CONSERVATION COMMISSION AGENDA

The Conservation Commission will hold this meeting as a virtual meeting on Thursday, February 18, 2021 at 7:00 pm. No in-person meeting will take place at City Hall.

1. 145 Warren Street – cont'd NOI – renovation and additional units onto single-family home – DEP File #239-882

2. 25 Bernard Street – NOI – teardown and rebuild single-family home – DEP File #239-883

TOPOGRAPHIC PLAN
 DEP ORDER 239-479
 942 WATERTOWN STREET
 NEWTON, MA.
 SCALE: AS NOTED
 JAN 28, 2021
 FEB 4, 2021 (FIELD CORRECTIONS)

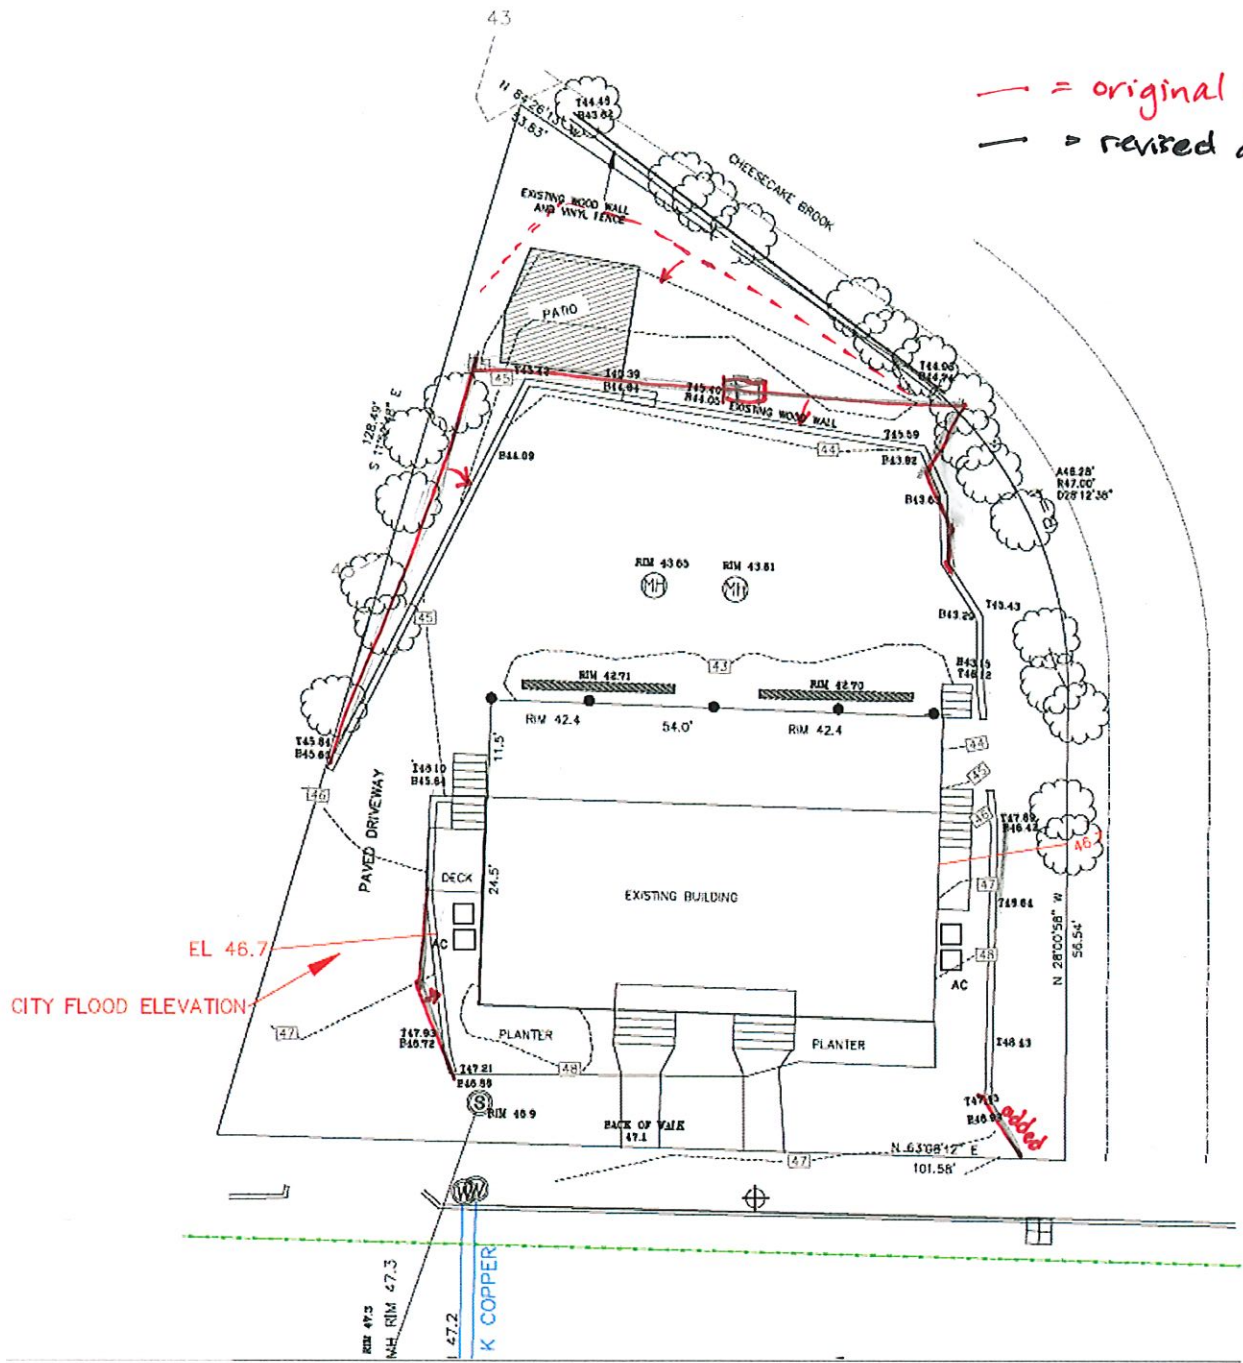
- **Staff Notes:**
 - A revised as-built has been submitted based on field corrections. No letter has been received with the revised plans stating what changed between the first and second as-built plans.

- Since the approved work was finished, further changes have been made to the site where were not reviewed or approved by our office.
 - Installation of 56' section of fence was added at the rear lot line along Cheesecake Brook.
 - A 12'x12' brick patio was installed.
 - No shrubs remain from the required planting plan.
- Staff Recommendations: Discuss the revised as-built and determine what steps are appropriate for closing out the permit and returning the site to compliance with the Wetlands Protection Act.

CONSTRUCTION PLANS
PART 7 OF 18

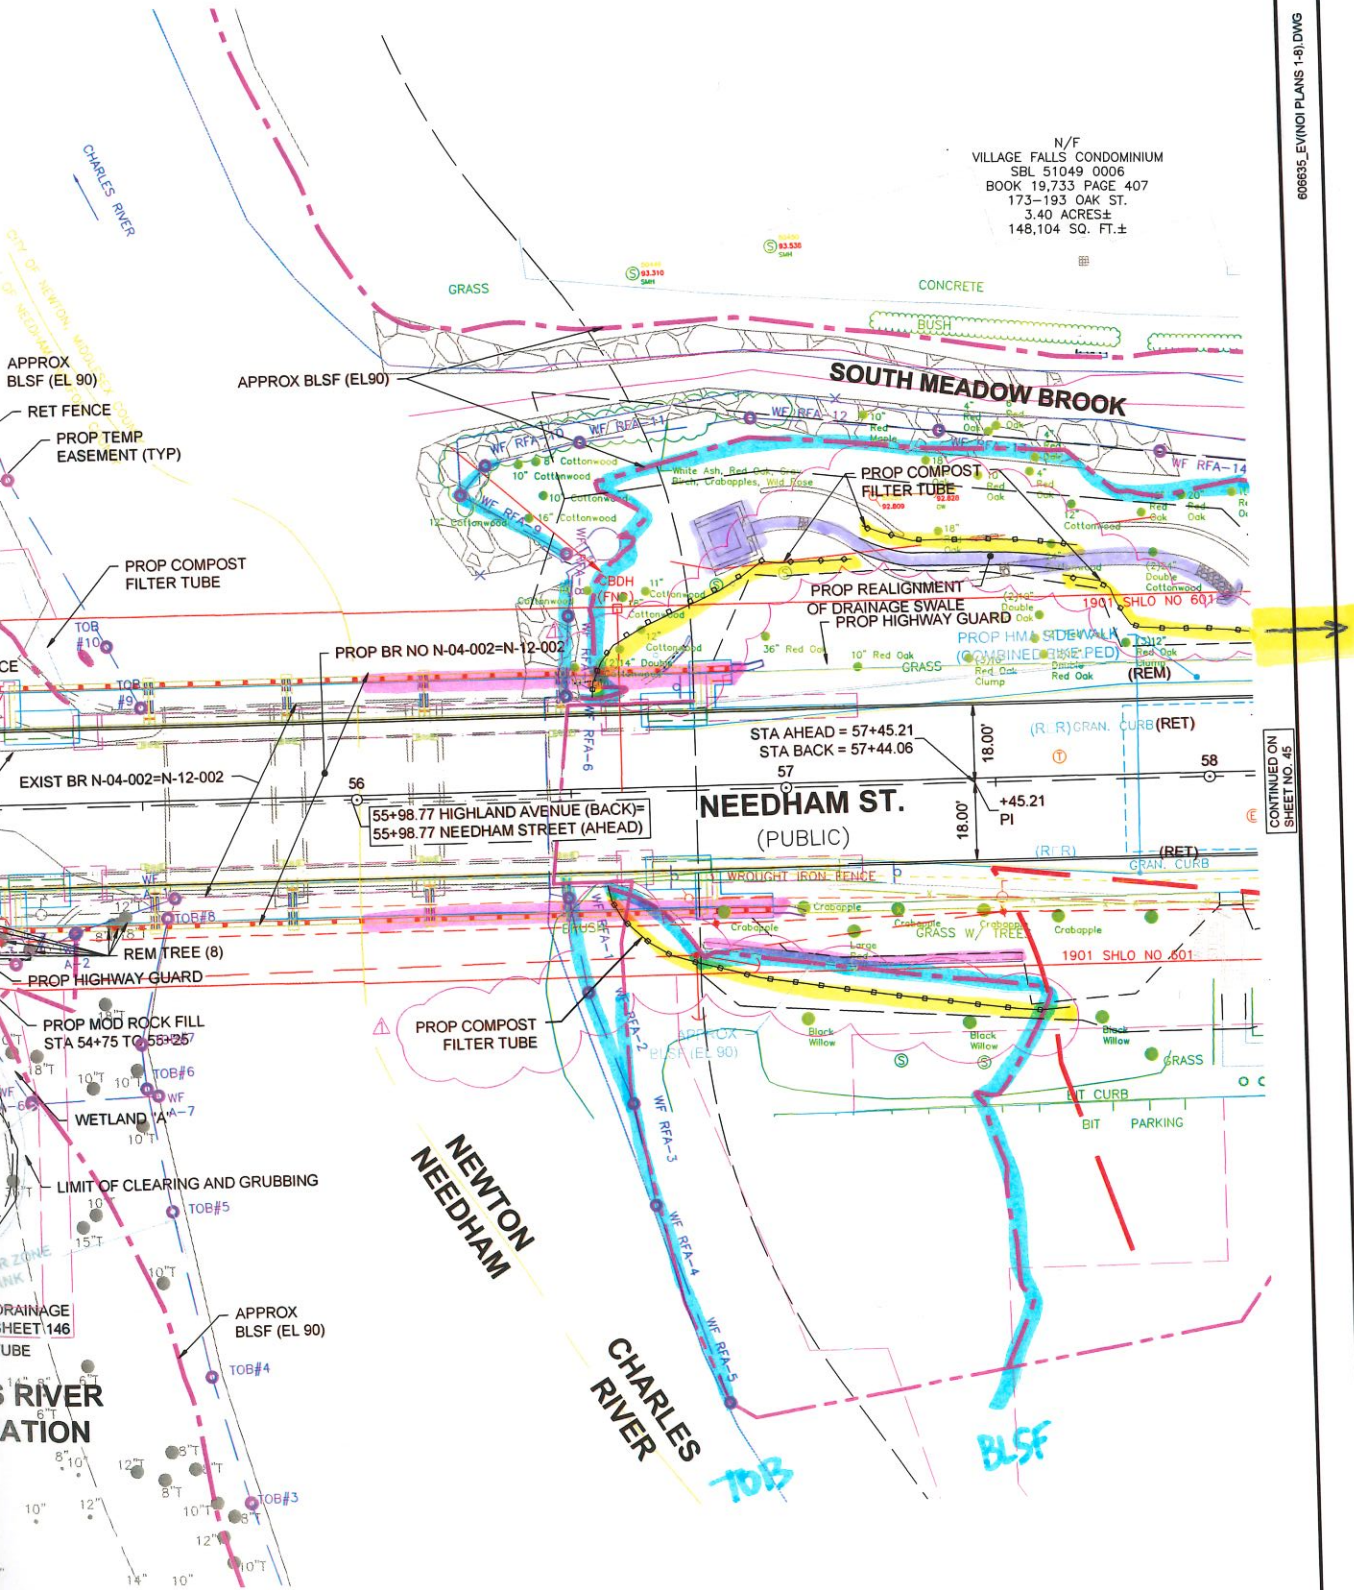
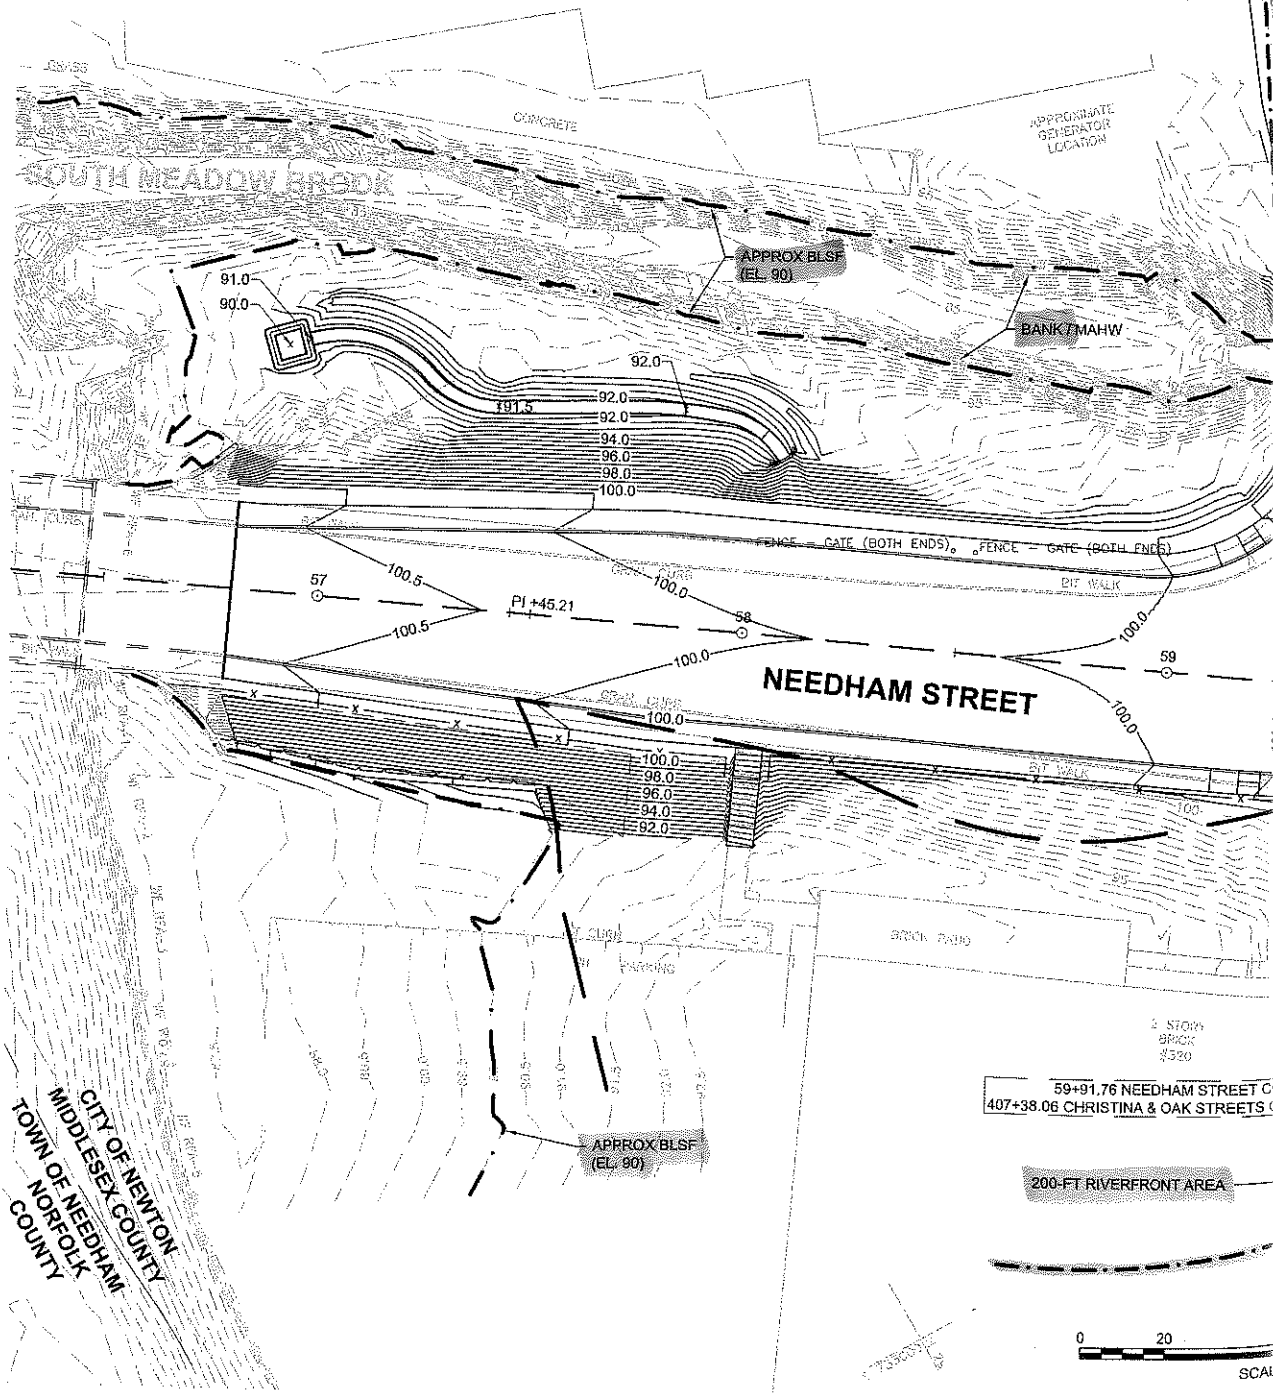
- Documents Presented: Colored plan excerpts
- Jurisdiction: Buffer Zone, Riverfront Area, BLSF, City Floodplain
- Staff Notes:
 - The project team is looking for approval to expand tree cutting (no grubbing) and expanded earthworks in a ~700 s.f. area on the west and ~900 s.f. on the east side of the bridge. The proposed expanded tree removal is for trees that were approved to be protected during construction and the expanded earthworks are due to occur in an area not previously shown within the limit of work.

- Issues to address: Contractor has revised plans not seen by ConCom and with some “discrepancies” where the two projects (the Oak St /Christina St intersection project (239-741) and the Needham Street/Highland Ave Bridge and Needham Street reconstruction project (239-815) meet.

- Retaining wall construction and grading (on east and west sides)
 - Erosion controls (not shown or revised plans)
 - Tree protection vs. removal
 - Temporary utility pole installation (other alternatives to location/height, etc. should be explored in an effort to save a large canopy tree close to the riverbank)

- Stantec response indicates that proposed expanded work area is already covered under the OOC
- Detailed plans of grading, vegetation, and stabilization needed
- The applicant team did attend multiple pre-construction visits and meetings with the Engineering Department, but may have not realized that a separate pre-construction site visit was required under the OOC.
- Staff Recommendations: Discuss the issues, requirements under the Act/regulations, and determine what form of filing would be most appropriate: request for minor plan change or amended OOC.
